Administrative Action Preliminary Subdivision

Case File / Name: S-14-16 / Waterview Townes

Nature of Case: Subdivision of an 11.93 acre parcel zoned R-10-CU into 53 residential townhome lots and two open space lots.

SUBJECT: S-14-16 / Waterview Townes

S-14-16 Preliminary Subdivision Layout

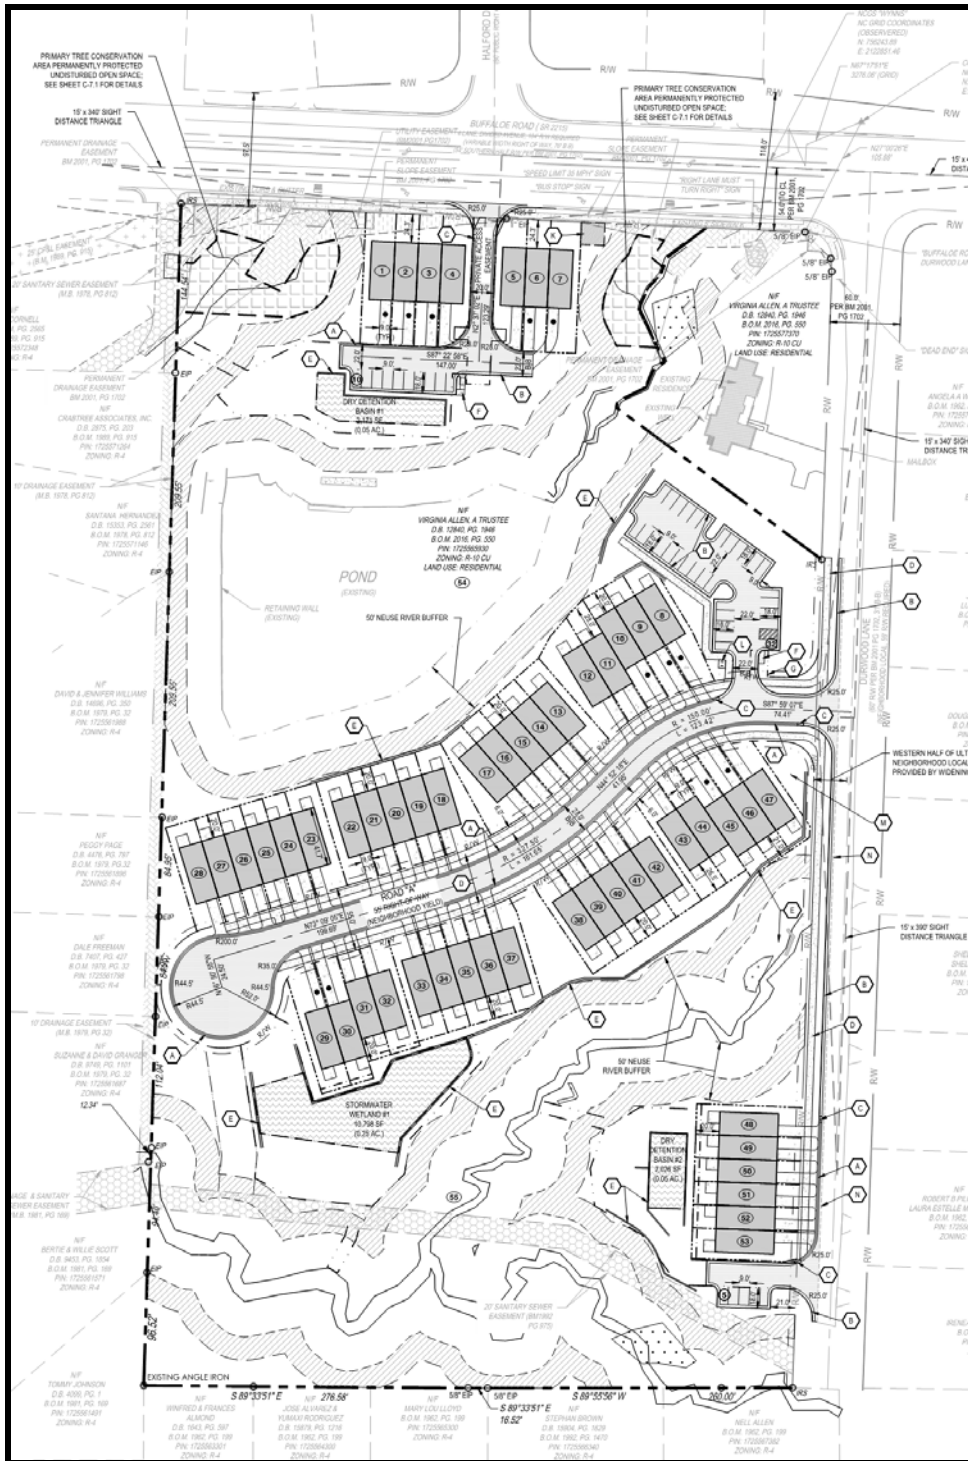
OFFICIAL ACTION: Approval with conditions

- (1) That a final tree conservation plan with permit be approved by the Forestry Specialist. The plan must show metes and bounds descriptions of all tree conservation areas, and tree protection fence around all tree conservation areas. Tree protection fence must be located in the field and inspected by the Forestry Specialist;

- (2) That in accordance with Part 10A Section 9.4.4, a surety equal to of the cost of clearing, grubbing and reseeding a site, shall be paid to the City;

- (3) That a 100-year floodplain analysis be submitted and approved by the Public Works Department;
- (4) That as the developer proposes to disturb a designated riparian buffer, the North Carolina Division of Water Quality shall approve the disturbance of the riparian buffer before any grading or approval of construction drawings, (whichever first occurs) and evidence of such approval shall be provided to the Stormwater Engineer in the Public Works Department, and a written watercourse buffer permit is thereby issued by the Inspection Department before commencement of work;

- (5) That a nitrogen offset payment must be made to a qualifying mitigation bank;
- (6) That plans for the shared stormwater devices be submitted and approved by the Public Works Department;
- (7) That a stormwater control plan with a stormwater operations and maintenance manual and budget shall be approved by the Stormwater

- (12) That a fee-in-lieu of construction be paid for 1' of sidewalk along the site's Buffalo Road frontage;
- (13) That a fee-in-lieu of planting be paid for street trees along the property's Buffalo Road frontage;

- (16) That a demolition permit be issued for the existing structure on site and this building permit number be shown on all maps for recording;
- (17) That a 15'x20' transit easement located on Buffalo Road be approved and be shown on all maps for recording, and that a transit easement deed be approved by the City and recorded with the local County Register of Deeds. The recorded copy of this transit easement be provided to the Planning Department prior to recording the lots;
